## The Committee of the Friends of Old Headington

### Supplementary Comment on the Height of Buildings in the Outline Plan for Barton

13/01383/OUT | Outline application (seeking means of access) for the erection of: A maximum of 885 residential units (Class C3); a maximum of 2,500 sqm gross Class A1, A2, A3, A4 and A5 uses (with a maximum of 2,000 sqm gross foodstore Class A1); a maximum of 50 extra care housing units; a maximum of 7,350 sqm GEA hotel (Class C1); a maximum of 3,000 sqm GEA Class D1, D2 floorspace (community hub and primary school); in development blocks ranging from 2 to 5 storeys with associated cycle and car parking, landscaping, public realm works, interim works and associated highway works. (Additional information - Landscape and Cultural Heritage Statement) | Land West Of Barton North Of A40 And South Of Boundary Brook Northern By-Pass Road Wolvercote Oxford Oxfordshire OX3 9SD

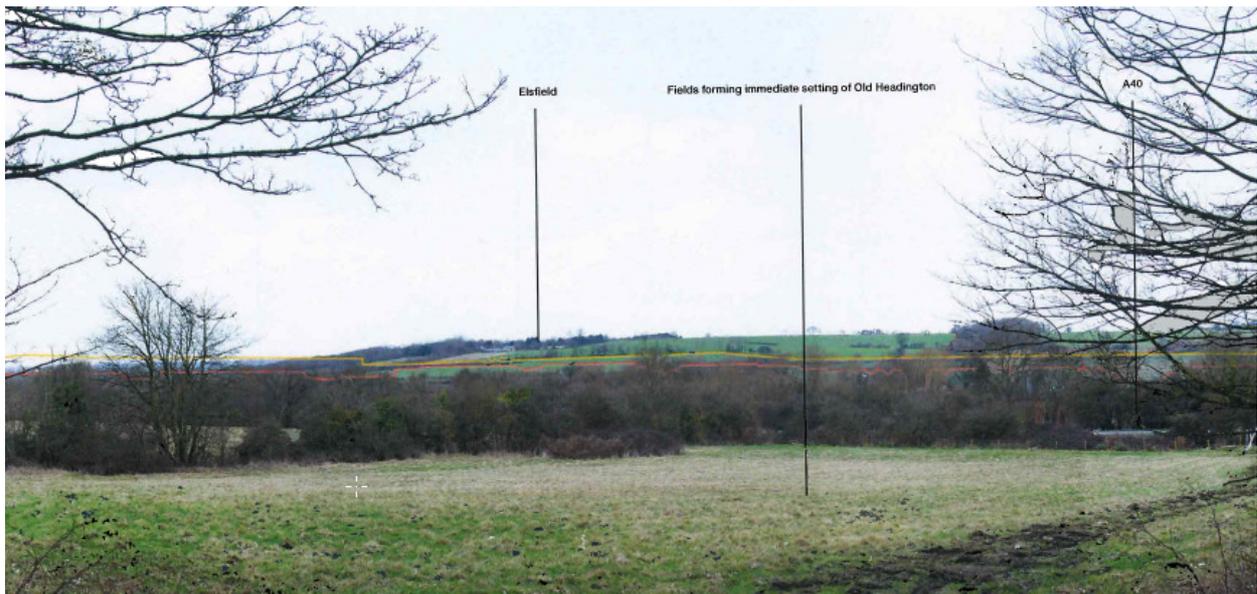
The "wireframe" illustration depicting the proposed heights of the residential and retail units as viewed from the south (page 12, fig. 6: view 3 (scan no. 3 attached)) therefore merits particular attention. When considering this wireframe illustration it is essential for Councillors and Officers to restrict their attention to the yellow 'Parameter Outline', as distinct from the 'Illustrative Outline', since the developers would be fully entitled to build to the full height of the Parameter Outline for much or all of the development:

These heights represent a completely unacceptable failure to take seriously the recommendations of the *Old Headington Conservation Area Appraisal*, since the views will clearly be irreparably damaged by intrusive buildings.

**We do not think that a development in such a sensitive context should rise higher than a level equivalent to a two storey building on the highest point of the site.**

It is important that the potential impact on local views is fully understood at this stage; pages 8 and 9 of the *Effects of the Proposed Development* imply much less impact than the “wireframe” views attached here as scans ‘Barton 1’, ‘Barton 2’, and ‘Barton 3’, which clearly demonstrate that various communities will suffer the loss of valued views.
